Access Compliance Report

Public Rights-of-Way

Intersection ID: N/A	Main Street: KIRKWYND COMMONS DR	Cross Street: TRAILMOOR RD	Location: NE
ADA ID: 7E5EE4B8BA21	Ramp Type: Perp	Initial Pass/Fail: Fail	Overall Compliance: No
Severity Score: 12.5			
Codes/Mitigation Info/Possible Solution		Field Measurements/Component Compliance

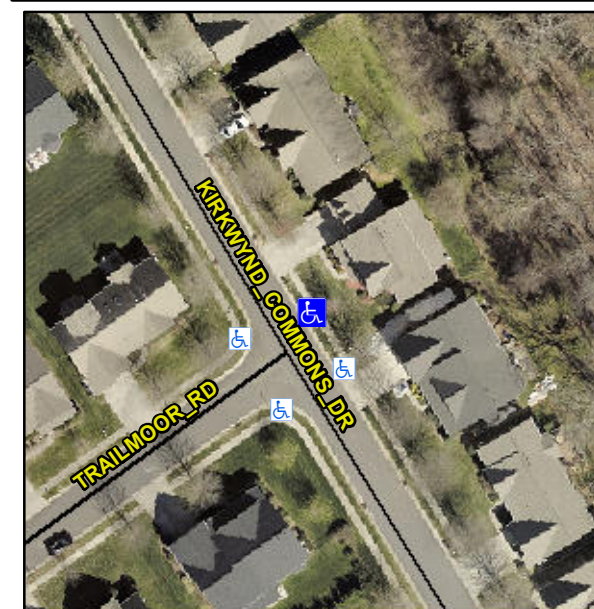
R304.2.2

Compliance	Description	Data	Compliance	Description	Data
N/A	Ramp Length (in)	48.0	No	Ramp Slope (%)	9.5
Yes	Ramp Width (in)	48.0	Yes	Ramp XSlope (%)	0.8
N/A	Flare Type LT	N/A	N/A	Flare Type RT	N/A
N/A	Flare Slope LT (%)	N/A	N/A	Flare Slope RT (%)	N/A
N/A	Flare Traversable LT?	N/A	N/A	Flare Traversable RT?	N/A
N/A	Landing Length (in)	N/A	N/A	DWS Provided?	N/A
N/A	Landing Width (in)	N/A	N/A	DWS Contrast?	N/A
N/A	Landing Slope (%)	N/A	N/A	DWS Length (in)	N/A
N/A	Landing X Slope (%)	N/A	N/A	DWS Full Width?	N/A
N/A	Landing Curb? (Y/N)	N/A	N/A	DWS Offset (in)	N/A
N/A	Shared Landing?	N/A			
N/A	Gutter Ponding?	N/A	N/A	Gutter Slope (%)	N/A
N/A	Gutter Lip Ht (in)	N/A	N/A	Gutter X Slope (%)	N/A
N/A	Painted X Walk1?	No	N/A	Painted X Walk2?	N/A
	X Walk 1 Direction	To SW		X Walk 2 Direction	N/A
N/A	X Walk 1 Width (in)	N/A	N/A	X Walk 2 Width (in)	N/A
	X Walk 1 Slope (%)	3.9		X Walk 2 Slope (%)	N/A
	X Walk 1 X Slope (%)	3.3		X Walk 2 X Slope (%)	N/A

Remove & Replace Entire Ramp.
